Core Bus Corridor 1: Clongriffin - Preliminary Submission

1.0 Introduction

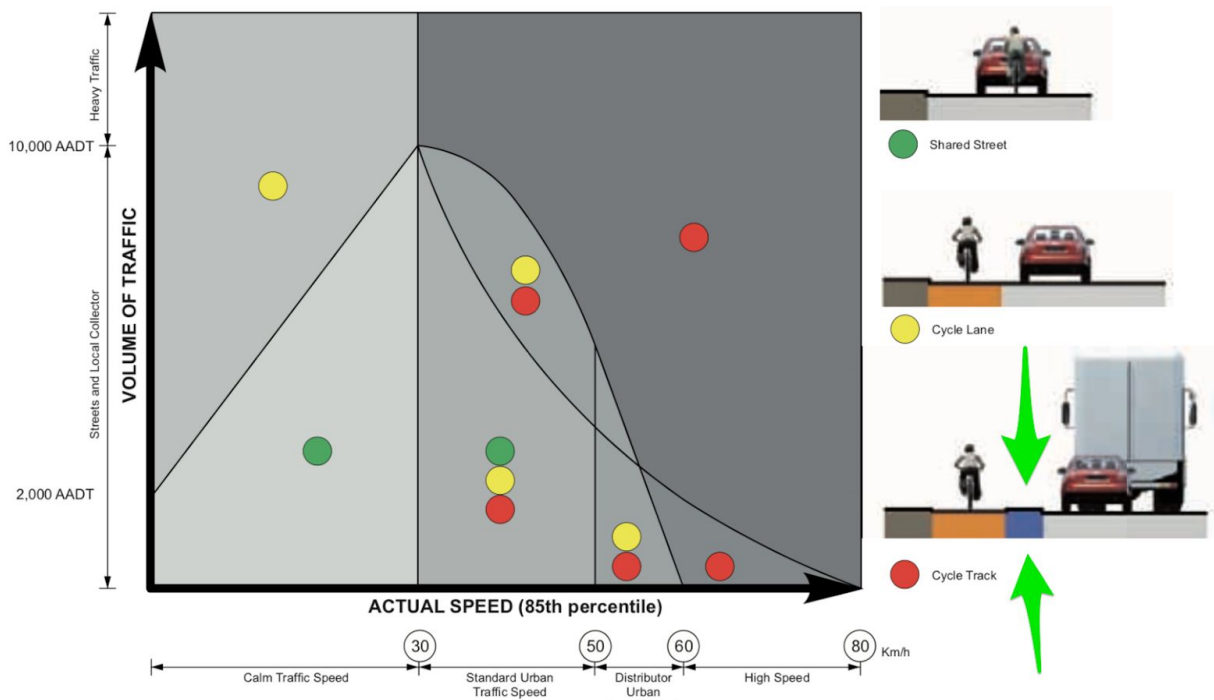
We recognise that achieving a 2.5m wide cycle track on all portions of this route may be challenging, however it is possible to achieve this width along large segments of the route by widening into the median or using grass verges beside the proposed cycle track. In constrained areas a cycle track width of 2m is acceptable, but should be implemented with caution.

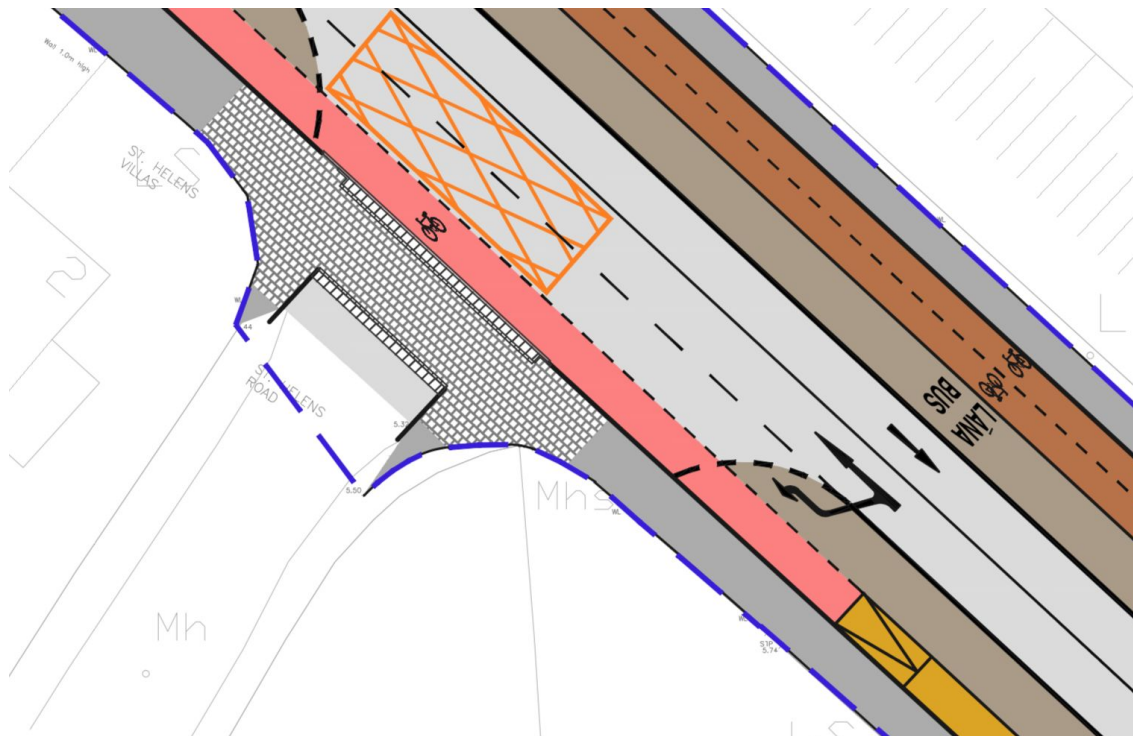
This form of junction design has been achieved along the soon to be constructed North Strand/Fairview cycle route project from Dublin City Council and the NTA. It uses a modified version of the protected junction design. The protected junction design also allows for right hand turns for cyclists.

The junction design also segregates pedestrians and cyclists by providing parallel crossings and designated spaces. This would eliminate shared spaces for pedestrians and cyclists. Shared spaces are disliked by pedestrians, cyclists and by people with disabilities. Parallel crossings also mean that cyclists don't have to use islands in the middle of the road that frequently are too small for bikes to easily manoeuvre around.

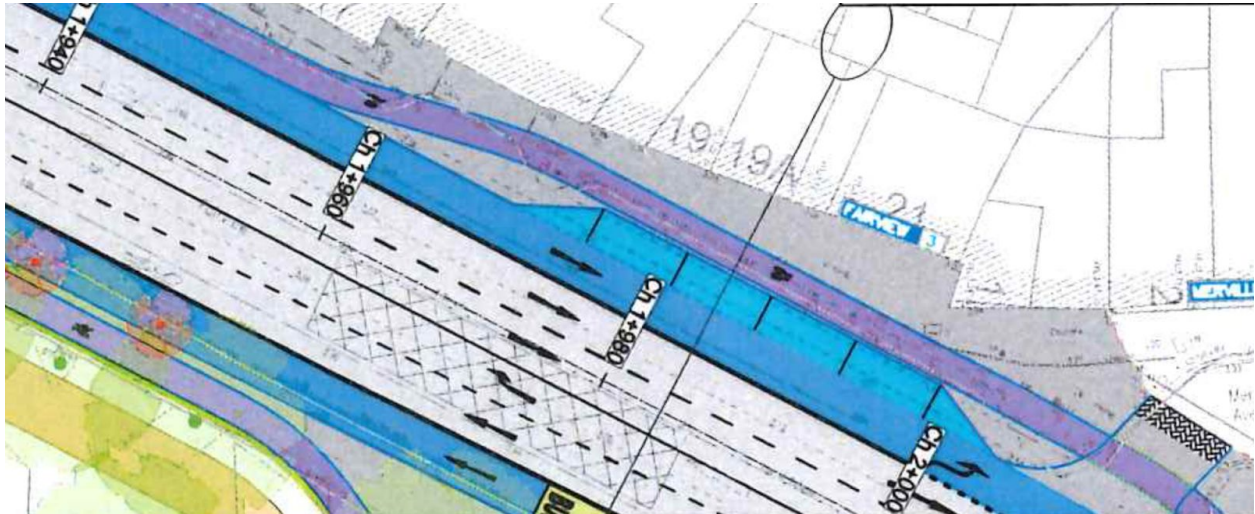
There are 7 of 30 locations where there are no bus stop bypasses for cyclists. There are many reasons we'd encourage the design team to include bus stop bypasses at all bus stop locations:

- Bus stop bypasses remove conflict between buses and cyclists. There is nothing more terrifying, particularly for a beginner or tentative cyclist than a 30 ton bus pulling into a bus stop on top of you
- Buses will operate more efficiently at stops because bus drivers will not need to wait for a slow cyclist to pass the bus stop before pulling in
- Bus Stop Bypasses allow pedestrians to alight and descend from buses without having to worry about conflict with cyclists

Cross-section of 15.6m

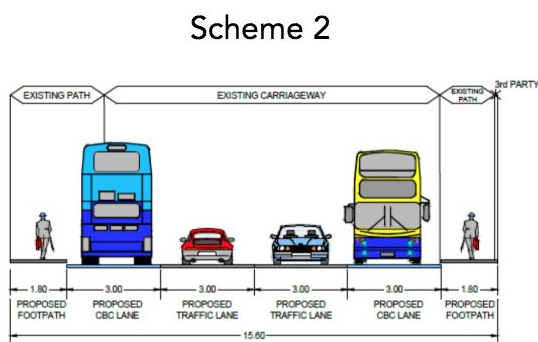
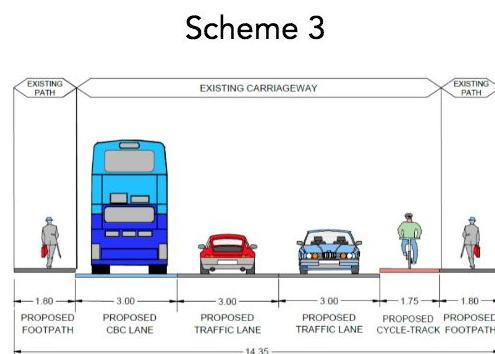
The MCA determined that Scheme 2 performed better than Scheme 3 on environment. However, this was a mistake in the analysis. In the most constrained section of the Malahide Road, here are the cross-sections for Scheme 2 and Scheme 3.

It is odd that Scheme 3, even with a narrower cross-section had more disadvantages than Scheme 2 on the environment criteria. In the MCA Tables, a listed disadvantage for Scheme 3 but not Scheme 2 in the Archeology/Cultural Heritage criteria:

The boundaries of 2 protected structures on Malahide Rd (62 & 64) may be affected by road widening.

However, Scheme 2, also impacts on the boundary of Malahide Road 62 & 64.

In the Flora and Fauna criteria, Scheme 3 had some advantages over Scheme 2 because of the need for less land take. Scheme 3 should have beaten Scheme 2 on the Environment criteria.

Figure 5.44 Cross Section B-B

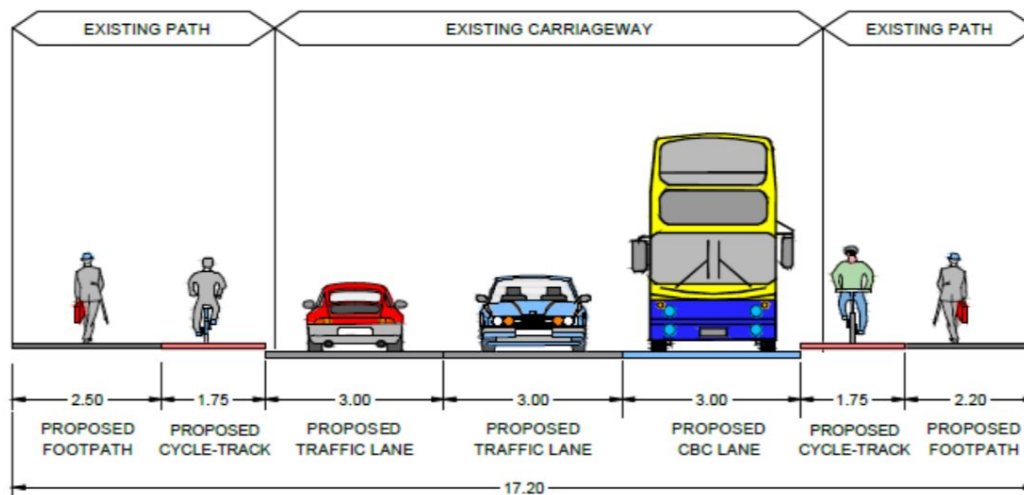
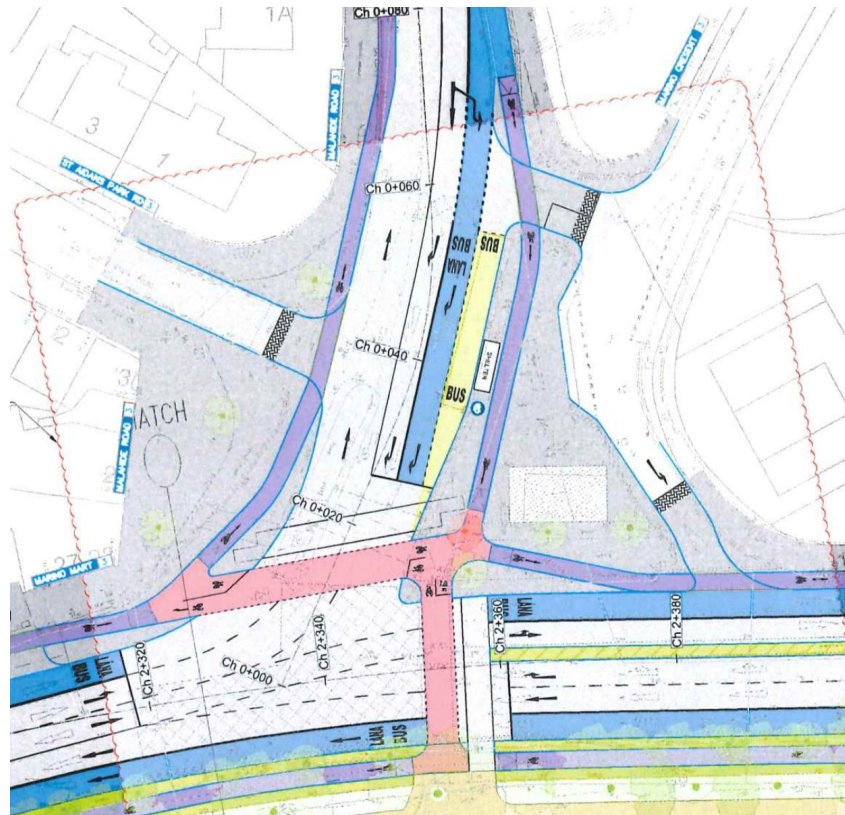
This cross-section is 17.2m wide. However, it uses different dimensions for the proposed footpaths than the other schemes it is being compared to. It seems odd that a 2.2-2.5 footpath is provided beside a cycle track but only 1.8m is acceptable beside a bus lane. Both Scheme 2 and Scheme 3 use the minimum accepted value of 1.8m for the proposed footpaths. If Scheme 1, followed suit then its cross-section would be 16.1m instead of 17.2m. This makes Scheme 1 only 50cm wider than Scheme 2.

The multi-criteria analysis is not comparing like with like, which undermines the analysis. Using a cross-section of 16.1m, and taking into account Issue 1 above, it is likely that Scheme 1 and Scheme 2 would have been very similar on the environment option.
